CHANGE ORDER NO.: 1

Owner: Christian County	Owner's Project No.: ITB #2024-15
Engineer: Great River Engineering	Engineer's Project No.: 4448.08
Contractor: KCI Construction Company	Contractor's Project No.: 24-063
Project: Christian County Jail – Sewer Improvements	
Contract Name: Christian County Jail – Sewer Improvements	
Date Issued: 12/12/2024	Effective Date of Change Order: 4/10/2025

CHRISTIAN COUNTY JAIL - SEWER IMPROVEMENTS
CHRISTIAN COUNTY, MISSOURI

WALNUT STREET PLAN AND PROFILE SEWER

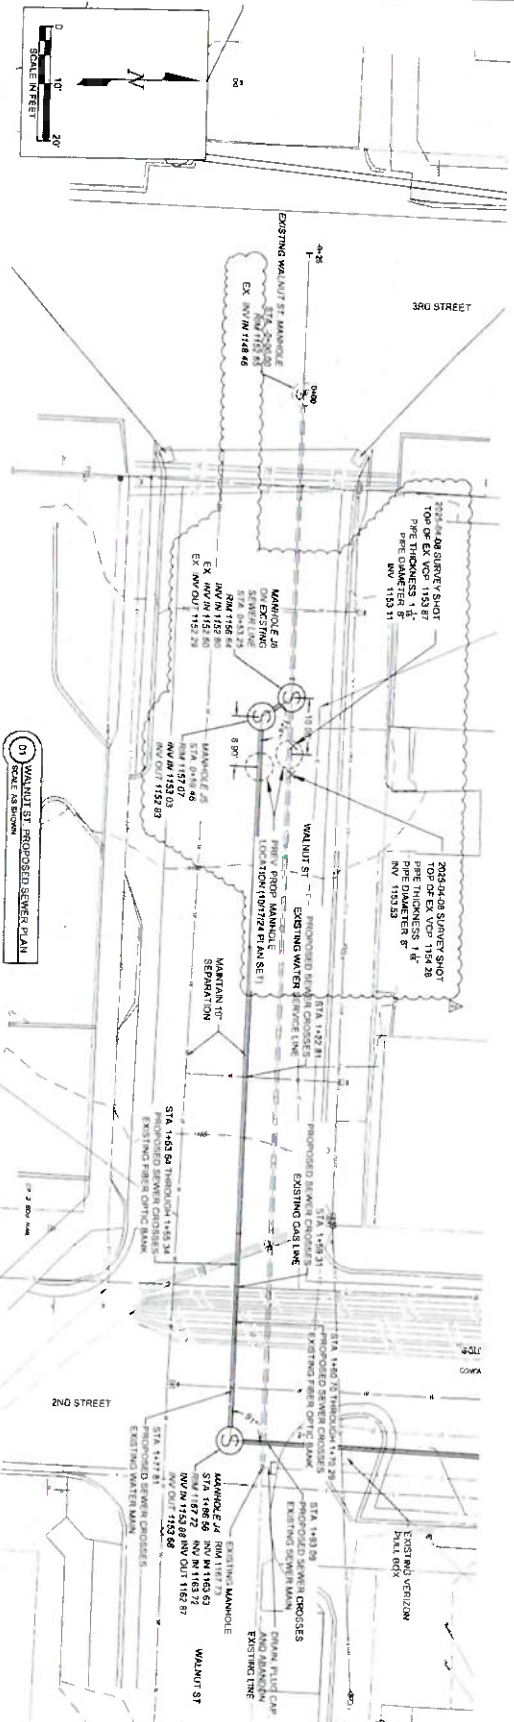
Description: Relocation of manholes J6 and J5. Adding an additional 10LF of 8" SDR-21 Gravity Sewer Piping, Excavation, and Backfilling.
